DATE: 12.20.2017
TO: ProTrak
FROM: Mitesh Baxi
 Traffic Engineering

■ **COURTYARD AT MIDTOWN VILLAGE [TRC Plan Review]**

↻ Initial Review Note ↻

BASE INFORMATION:

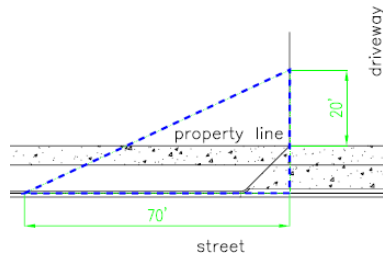
The site is within 500' of a Traffic Signal. Revise all sheets to accurately illustrate the existing conditions on and surrounding this parcel. Show all adjacent traffic signs, lane configurations, traffic control devices and pavement markings for the intersection of Longstreet Dr and Shipyard Blv. Please refer to the Technical Standards and Specifications Manual (link is below) Ch. VII C.1.a.2. for specific information and distance requirements. Contact Traffic Engineering at 341-7888 if you need assistance locating these elements.
